MINERALS PROGRAM INSPECTION REPORT PHONE: (303) 866-3567

MINE/PROSPECTING ID#:	MINERAL:	COUNTY:		
	P-2016-019	Silver	Custer		
	INSPECTOR(S):	INSP. DATE:	INSP. TIME:		
	Brock F. Bowles	August 27, 2019	11:00		
	OPERATOR REPRESENTATIVE:	TYPE OF OPERATION:			
	Rick Squire	MP - Mineral Prospecting			
REASON FOR INSPECTION:		BOND AMOUNT:			
	Partial Bond	\$16,134.00			
	POST INSP. CONTACTS:	JOINT INSP. AGENCY:			
	None	None			
INSPECTOR'S SIGNATURE:		SIGNATURE DATE:			
Brok Sauls		September 10, 2019			
	1	P-2016-019 INSPECTOR(S): Brock F. Bowles OPERATOR REPRESENTATIVE: Rick Squire BOND CALCULATION TYPE: Partial Bond POST INSP. CONTACTS: None INSPECTOR'S SIGNATURE:	P-2016-019 INSPECTOR(S): Brock F. Bowles OPERATOR REPRESENTATIVE: Rick Squire BOND CALCULATION TYPE: Partial Bond POST INSP. CONTACTS: None INSPECTOR'S SIGNATURE: Signature Silver INSP. DATE: August 27, 2019 TYPE OF OPERATOR PROPERATOR

This inspection was conducted by Brock Bowles of the Division of Reclamation, Mining and Safety (Division). Rick Squire, representing Viscount Colorado Holdings (Operator), was present for the inspection. The Kate Project is a prospecting permit located approximately 1/2 mile northwest of Silv

Drill hole P17002

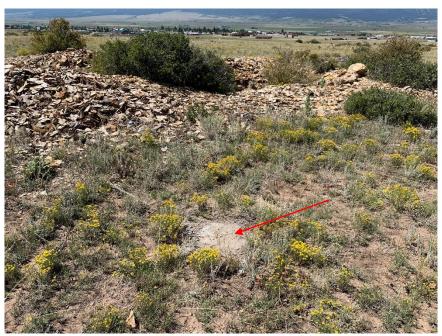
Drill hole P17002 needs additional work. The casing needs to be cut below the surface and filled with concrete. The operator shall submit photo documentation showing that the casing was cut below the surface and filled with concrete within 30 days of the inspection for the issue to be considered resolved. If the bore hole is not repaired by September 26, 2019, the surety release application will be denied.
